ARCHITECTURAL REVIEW BOARD MEETING
CITY HALL, 385 SOUTH GOLIAD STREET, ROCKWALL, TEXAS
APRIL 29, 2025 IN THE CITY COUNCIL CONFERENCE ROOM AT 5:00 PM

PROJECT COMMENTS

PROJECT NUMBER: SP2025-014
PROJECT NAME: Site Plan for a Retail/Office Building
SITE ADDRESS/LOCATIONS: 2351 HARBOR HEIGHTS DR

04/24/2025: SP2025-014 Site Plan for 2351 Harbor Heights Drive

SITE PLAN

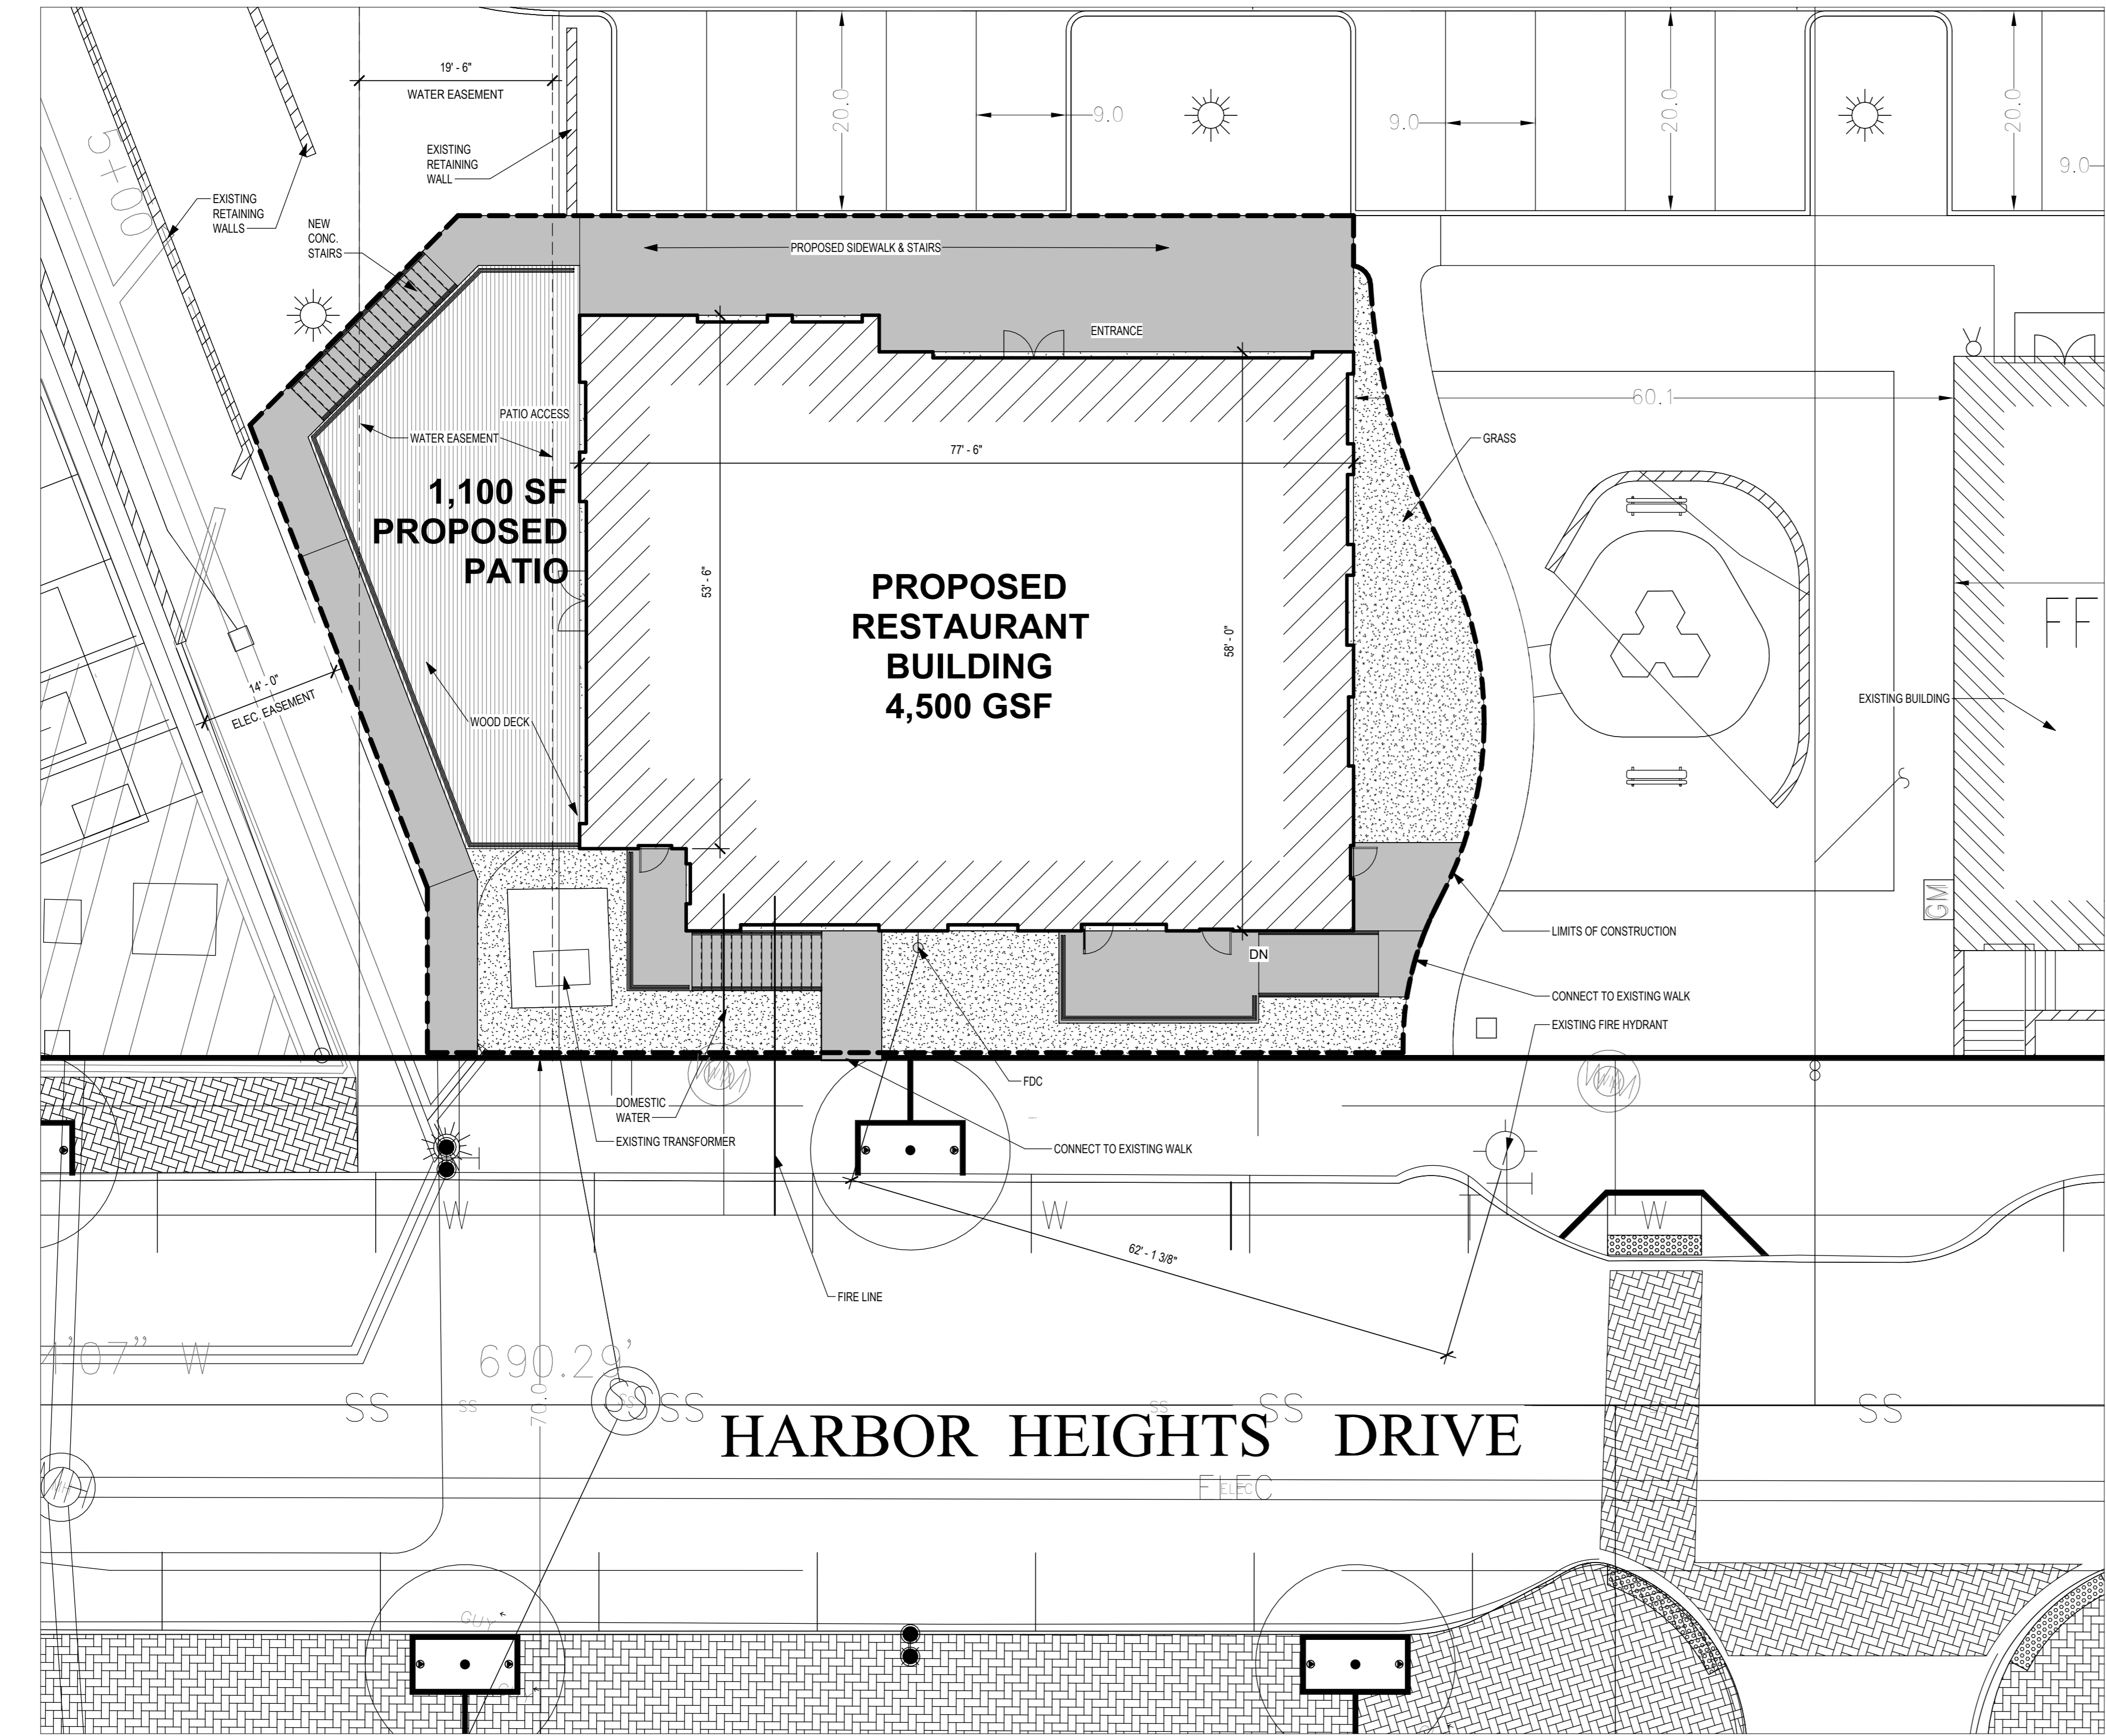
(1) Pad mounted utility equipment, and air conditioning units, shall be screened from horizontal view from any adjacent public street and from any adjacent property. Utility equipment and air conditioning units shall be screened utilizing plantings berms, or walls matching the main structure. (Subsection 01.05.C, Article 05, of the UDC) Please indicate on your site plan if there are any pad mounted utility equipment. Utility equipment will be subject to screening if found later at engineering or building permit.

(2) The maximum parking required for this lot is 186 parking spaces according to the updated shared parking calculation attached. This lot is short 25 parking spaces.

(3) The maximum square footage for this building is 4,000 SF according to the PD Development Plan [Ordinance No. 19-25]. This will be a variance to the PD Development Plan.

04/23/2025: * NEED TO SEE ADA PARKING AND ACCESS TO THE BUILDING

EXTERIOR
ELEVATIONS

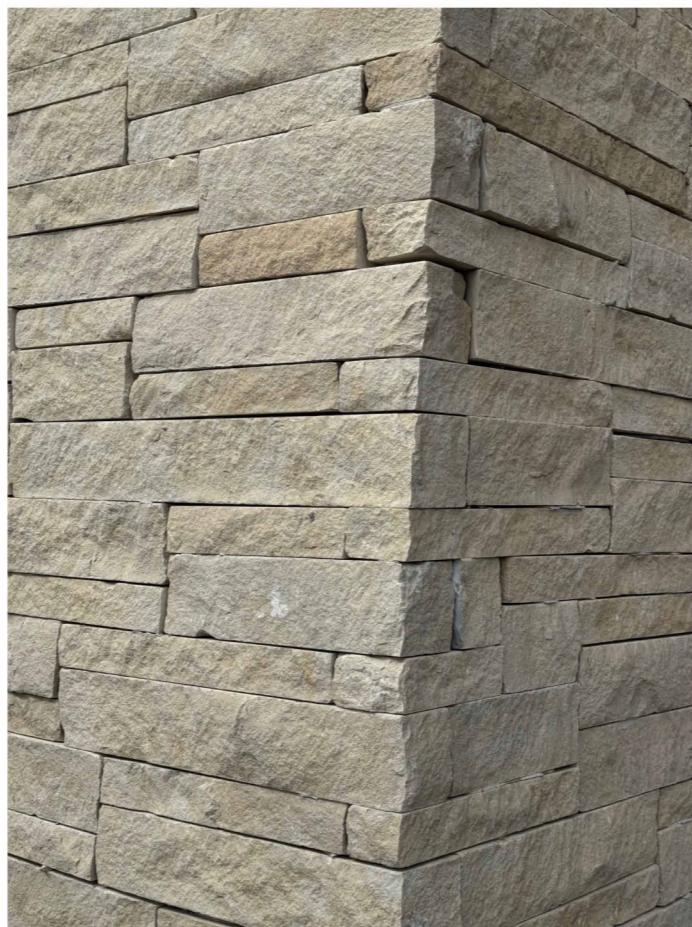
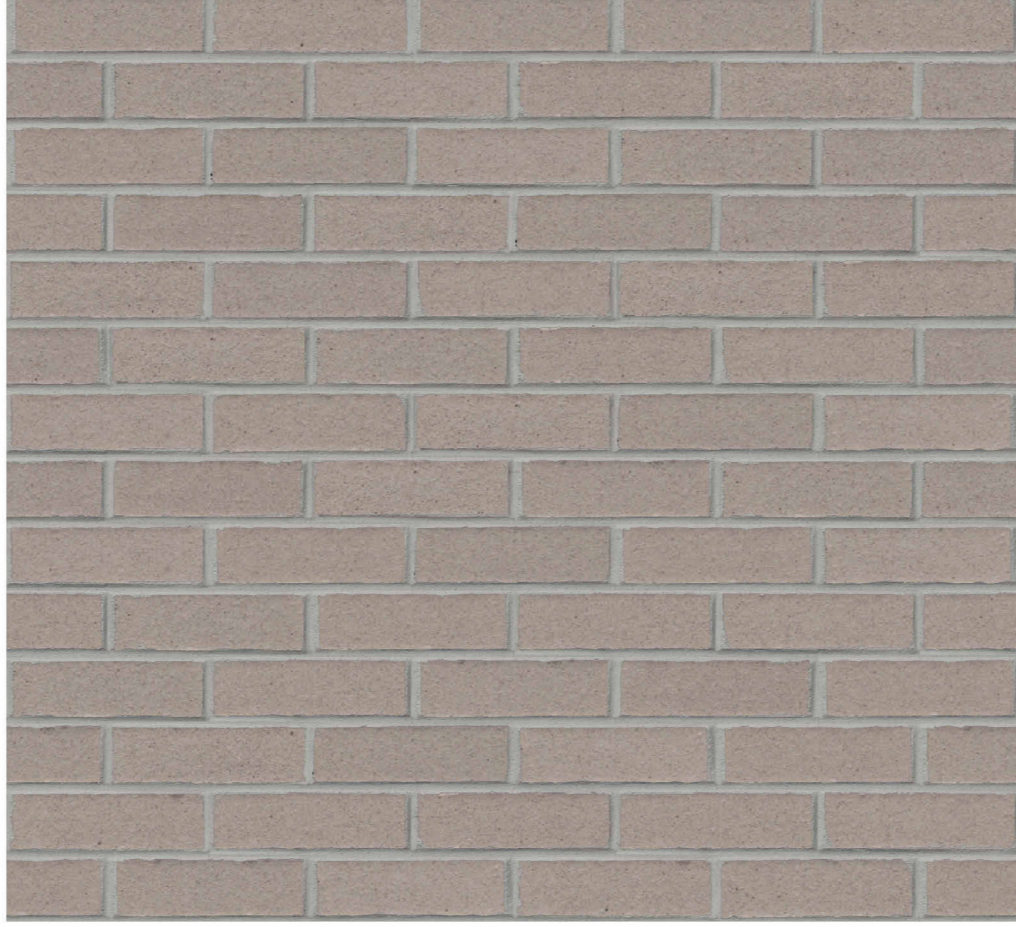
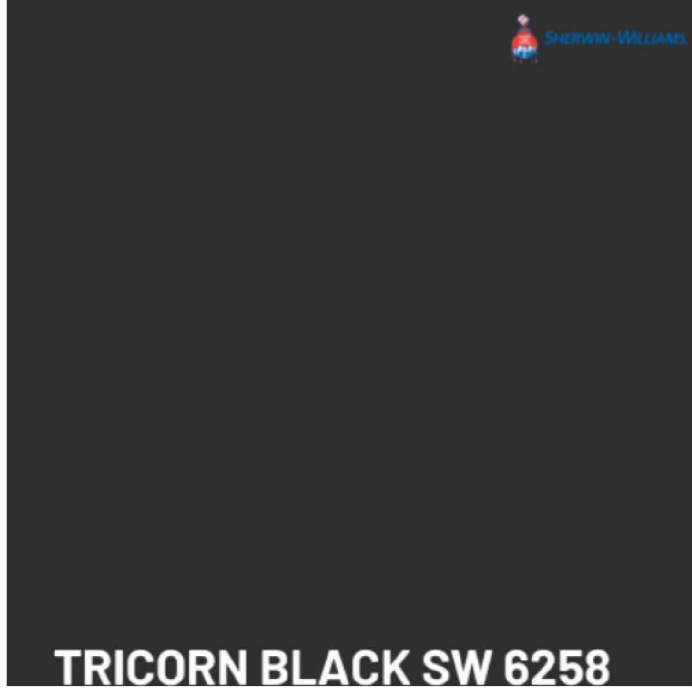
- (1) Indicate exterior elevations adjacent to public right-of-way.
- (2) All buildings must be designed such that no roof mounted mechanical equipment, HVAC, or satellite dishes shall be visible from any direction. (Subsection 01.05.C, of Article 05, of the UDC)

- (3) All parapets shall be extended back and finished on the interior side using the same materials as the exterior facing walls. (Subsection 04.01, of Article 05, of the UDC)

- (4) The proposed buildings' facades do not meet the Commercial Building Articulation Standards for wall projections. (Subsection 04.01.C, of Article 05, of the UDC) This will require a variance from the Planning and Zoning Commission.

- (5) All structures that have a building footprint of less than 6,000 SF shall be constructed with a pitched roof. (Subsection 06.02.C.2, of Article 05, of the UDC) This will require a variance from the Planning and Zoning Commission.

- (6) All buildings shall be architecturally finished on all four (4) sides utilizing the same materials, detailing, articulation and features. (Subsection 06.02.5, of Article 05, of the UDC and Planned Development District 32 [Ordinance 19-25]). This will require a variance from the Planning and Zoning Commission.

- (1) Four-sided Architecture. According to Article 05, General Overlay District Development Standards, of the Unified Development Code (UDC), "all buildings shall be architecturally finished on all four (4) sides utilizing the same materials, detailing, articulation and features. In addition, a minimum of one (1) row of trees (i.e. four [4] or more accent or canopy trees) shall be planted along perimeter of the subject property to the rear of the building." In this case, the proposed building does not meet the articulation standards for all four (4) facades.

- (2) Roof Design Standards. According to Article 05, General Overlay District Development Standards, of the Unified Development Code (UDC), "(a)ll structures that have a building footprint of less than 6,000 SF shall be constructed with a pitched roof. Those structures having a footprint 6,000 SF or greater shall have the option of being constructed with either a pitched, parapet, or mansard roof system as long as the roof system is enclosed on all sides. Standing seam metal roofs shall be constructed of a factory-treated, non-metallic, matte finish to avoid glare. Metal roofs with lapped seam construction, bituminous built-up roofs, and/or flat membrane type roofs that are visible from adjacent public right-of-way shall be prohibited." In this case, the proposed building has a flat roof and therefore does not meet this standard.

LANDSCAPE PLAN

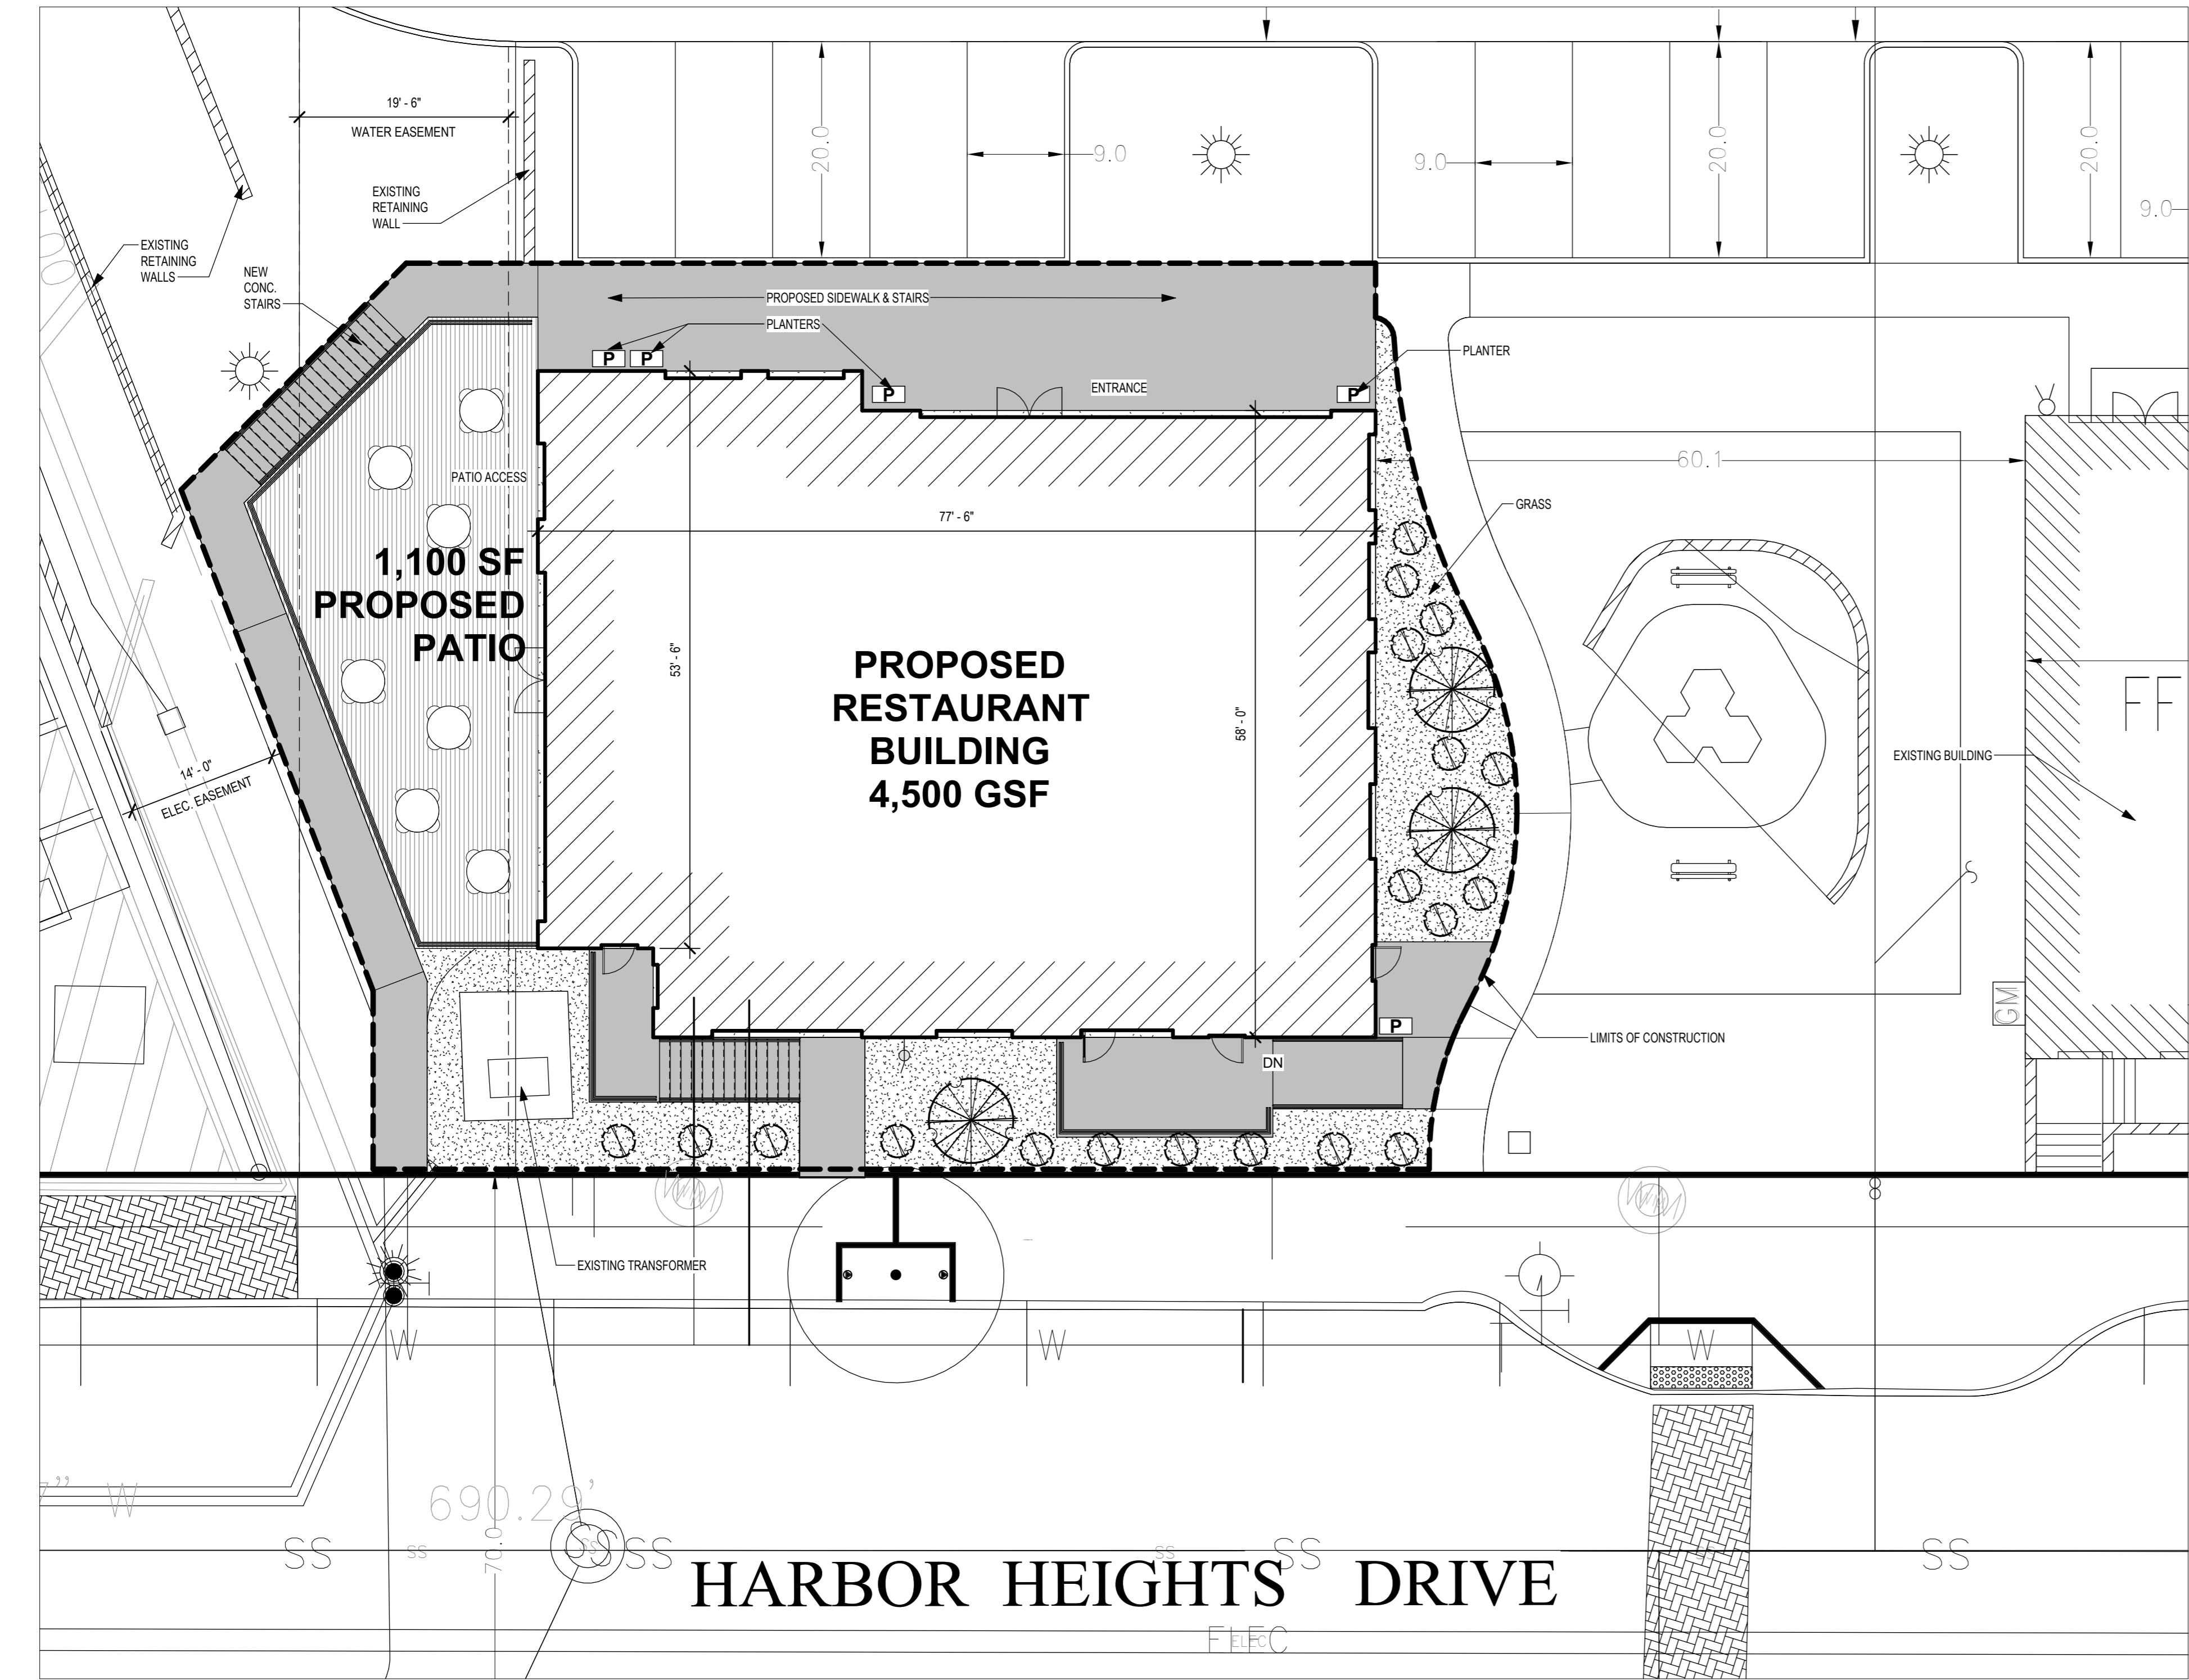
- 1) Provide evergreen shrubs screening the existing transformer. (Subsection 01.05.C, Article 05, of the UDC)
